Item 6.**Development Application: 36 Selwyn Street, Paddington - D/2024/10**

File No.: D/2024/10

Figure 7: Proposed First Floor Plan

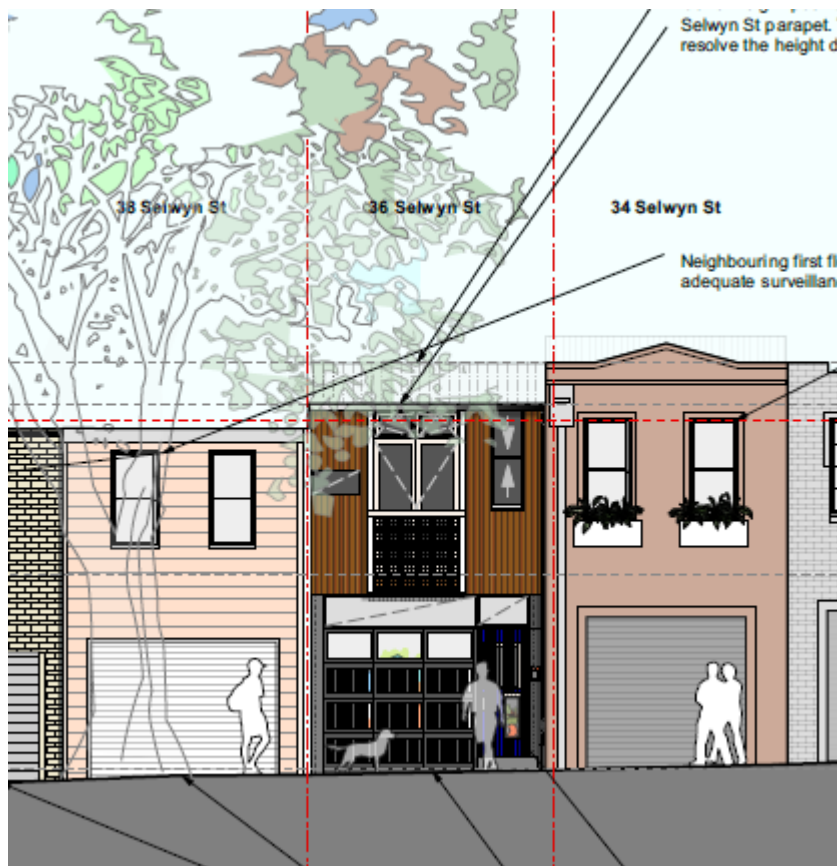
8. A further request for additional information and amendments was sent to the applicant on 23 April 2024. The following was requested:
 - (a) The proposed clerestory windows must be deleted.

- (b) The proposed bay window and planter box over the property boundary must be removed as no portion of the proposed structure shall encroach upon Council's footpath area.

4.1.3.6 Visual privacy	Yes	<p>The first-floor window to the hallway on the western elevation of the secondary dwelling is to be installed with obscure glazing to achieve acceptable visual privacy protection. It is noted that fluted glass is proposed for this window. A condition is recommended in Attachment A to reinforce the requirement for obscure glazing to be installed to the secondary dwelling.</p>

- The proposed clerestory windows have been deleted from the design and replaced with skylights.

- The proposed bay window and planter box have been deleted from the design and replaced with a façade opening on the first floor with French doors and a balustrade facing Iris Street.

- Response:** A condition is recommended in Attachment A to require obscure glazing to be installed on the first floor window to the hallway on the western elevation of the secondary dwelling, to ensure that overlooking/privacy effects from this window is managed and minimised.

Figure 9: Proposed West Elevation

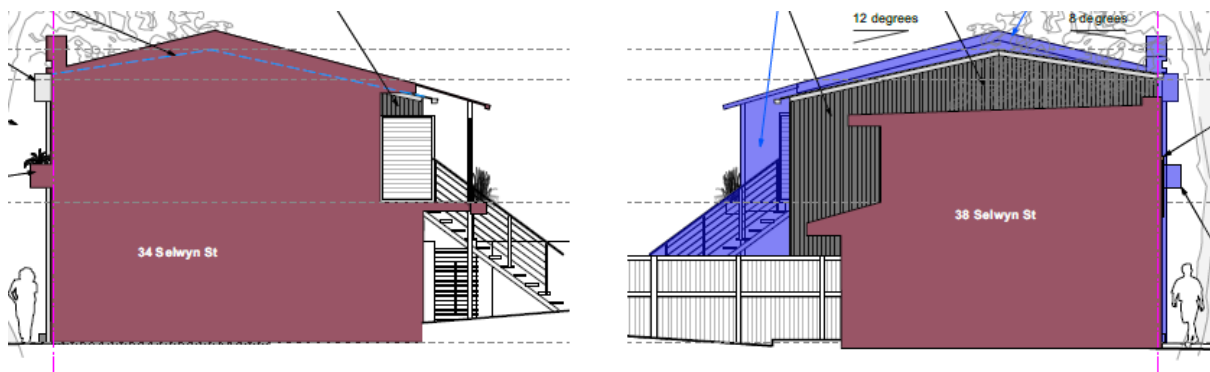
- (f) The east and west orientations on the following drawings appear to be labelled incorrectly and should be updated accordingly:
 - Drawing No. DA 20 Issue B - Elevation West (Iris Street)

- Correct orientation labels on the elevation and section drawings.
 - Updated landscape plan.
 - (c) An amended Schedule of Colours, Materials and Finishes

Figure 11: Shadow Diagrams

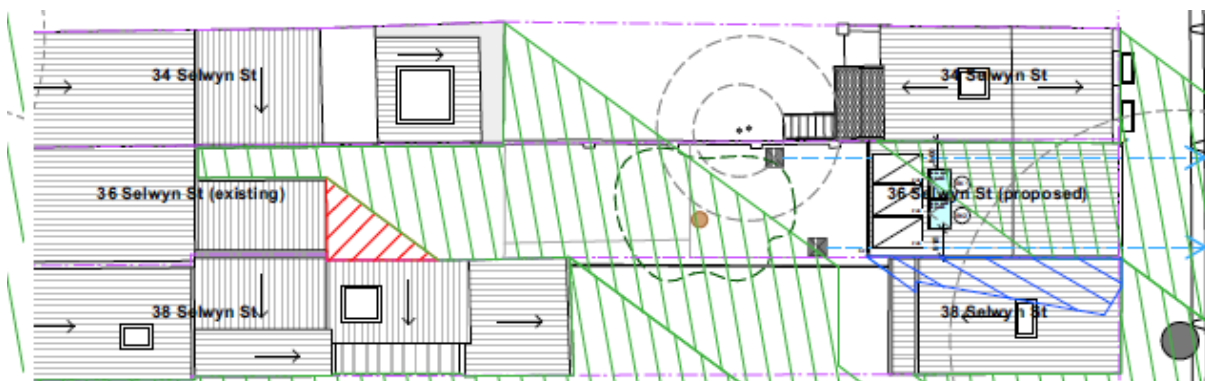
44. Section 4.1.3 of the Sydney DCP 2012 recommends that at least 50% of the private open space and 1 sqm of living room windows of the subject and neighbouring dwellings should achieve a minimum of two hours of direct sunlight between 9:00am and 3:00pm at the winter solstice. Section 4.1.3 of the Sydney DCP 2012 further states that new development is not to create any additional overshadowing where solar access is less than two hours between 9am and 3pm on 21 June.
45. To enable an assessment of the amended proposal, the applicant has provided shadow diagrams, which are reproduced in Figure 11 below. The diagrams identify the overshadowing by existing structures, including boundary fences, within the subject site (in red) and neighbouring properties (in green). Overshadowing caused by the proposed development is shown hatched in blue.

47. The proposed development will result in overshadowing of a minor extent of the skylight on the existing rear laneway building at 38 Selwyn Street. Notwithstanding, a review of the approved floor plans for the rear studio at 38 Selwyn Street indicate that the principal living room windows are located on the eastern elevation facing Iris Street, which the shading diagrams demonstrate will not be impacted by overshadowing from the proposal. As such, the proposed development will achieve the recommended level of solar access to primary living room windows on neighbouring sites.

48. Overall, the proposal is considered to maintain an acceptable level of solar access to the subject site and adjoining property to the south.
